# CITY OF ALBUQUERQUE

**RE: 2945 Trellis Dr. NW**  
**Grading and Drainage Plan**  
**Engineer's Stamp Date: 10/03/22**  
**Hydrology File: G12D037B**

## DRAINAGE AND TRANSPORTATION INFORMATION SHEET (REV 6/2018)

ENGINEER'S SEAL	LOTS A-4-B LANDS OF MICHAEL J. SNOW & ELIZABETH T. SNOW	DRAWN BY DEM
  10/3/22		DATE 10-2-22
DAVID SOULE P.E. #14522	GRADING AND DRAINAGE PLAN	LI A4A - A4C Lands of Michael Snow.dwg
	 P.O. BOX 83624 ALBUQUERQUE, NM 87199 (505) 321-9099	SHEET #  C1
		JOB #  _____

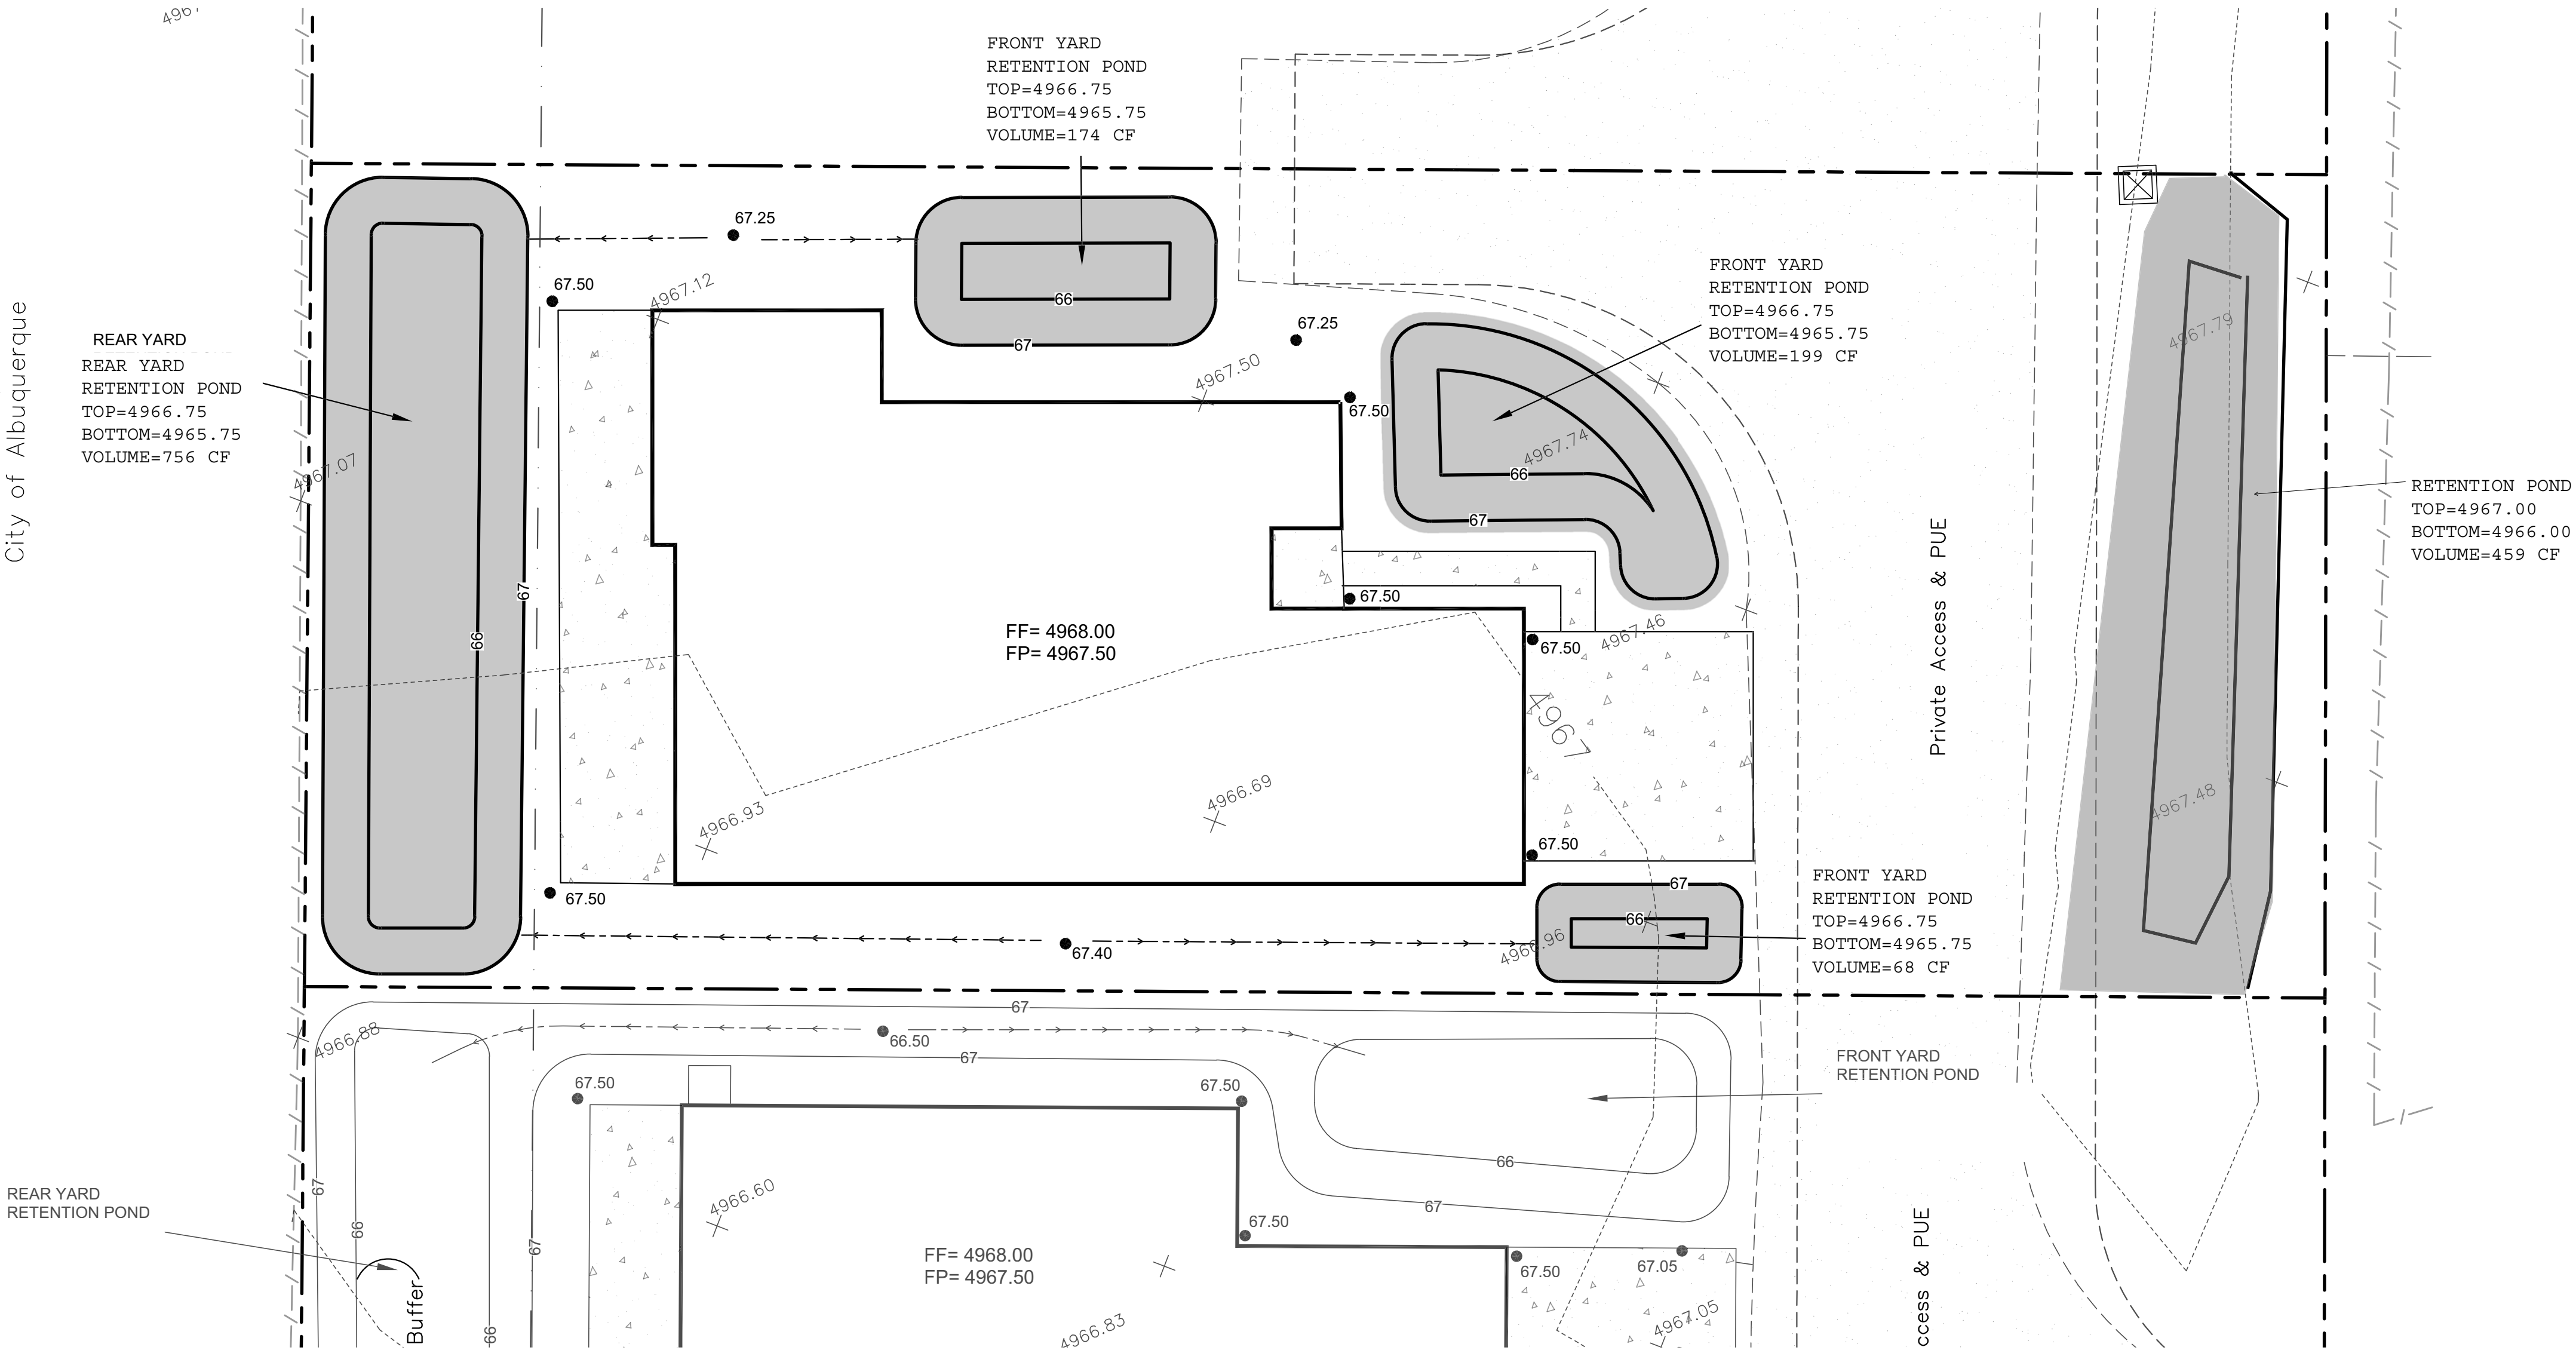
Based upon the information provided in your submittal received 10/04/2022, the Grading & Drainage Plan is approved for Grading Permit (earthwork can get started for the earth pad on the house).

1. Once the grading is complete, a pad certification (meaning that the earthwork is complete) will be required. Please include a site photo with the submittal. Also, at the time of pad certification approval, Hydrology will concurrently approve the Grading & Drainage Plan for Building Permit.
